Access Compliance Report Public Rights-of-Way (Curb Ramps)

Main Street: **ELMORE WAY** Cross Street: **JACKSON ST** Location: **SE**

ADA ID: **RPRK211005141724** Ramp Type: **Type 1 - Perpendicular Diagonal** Initial Pass/Fail: **Fail** Overall Compliance: **No** Severity Score: **30**

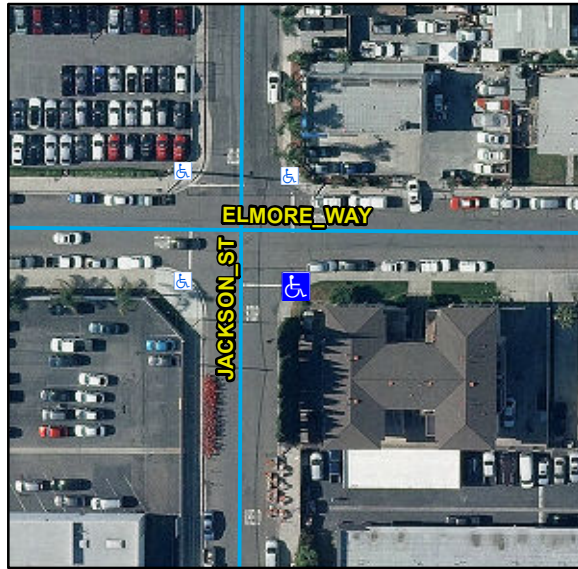
R304.2.2, R302.7.2, STD 1115

Compliance	Description	Data	Compliance	Description	Data
N/A	Ramp Length (in)	62	N/A	Flare Type LT	
Yes	Ramp Width (in)	48			N/A
No	Ramp Run Slope (%)	14.2	N/A	Flare Slope LT (%)	N/A
Yes	Ramp Cross Slope (%)	0.8	N/A	Flare Traversable LT	N/A
N/A	Landing Present	N/A	N/A	Flare Type RT	
N/A	Landing Length (in)	N/A			N/A
N/A	Landing Width (in)	N/A	N/A	Flare Slope RT (%)	N/A
N/A	Landing Run Slope (%)	N/A	N/A	Flare Traversable RT	N/A
N/A	Landing Cross Slope (%)	N/A	N/A	DWS Provided	N/A
N/A	Landing Movement Obstructed?	N/A	N/A	DWS Contrast	N/A
	Landing Movement Type	N/A	N/A	DWS Length (in)	N/A
N/A	Landing Shared	N/A	N/A	DWS Full Width	N/A
N/A	Clear Space	Yes	N/A	DWS Offset Left (in)	N/A
N/A	Clear Space To Crosswalk (in)	N/A	N/A	DWS Offset Right (in)	N/A
N/A	Marked Crosswalk 1	No	N/A	Marked Crosswalk 2	No
	Crossing 1 Direction	N		Crossing 2 Direction	W
	Marked Crosswalk 1 Width (in)	N/A		Marked Crosswalk 2 Width (in)	N/A

N/A	Ramp Inside Crosswalk 1	N/A	Yes	Ramp Inside Crosswalk 2	N/A
	Crossing 1 Slope (%)	6.3		Crossing 2 Slope (%)	1
	Crossing 1 Cross Slope (%)	2.1		Crossing 2 Cross Slope (%)	3.4
N/A	Gutter Ponding	N/A	No	Curb Slope	5.2
No	Gutter Lip Height (in)	0.5		Road Run Slope (%)	2.5
N/A	Gutter Run Slope (%)	N/A		Road Cross Slope (%)	7.1
N/A	Gutter Cross Slope (%)	N/A			
Yes	Overall Surface Condition: Acceptable		Yes	Perp Joint Present	Yes
	Cross Gutter Present?	No		Spandrel Present?	No
	Replace Cross Gutter?	N/A		Replace Spandrel?	N/A

Remove & Replace Curb Ramp With Two New Directional Ramps or Equivalent.
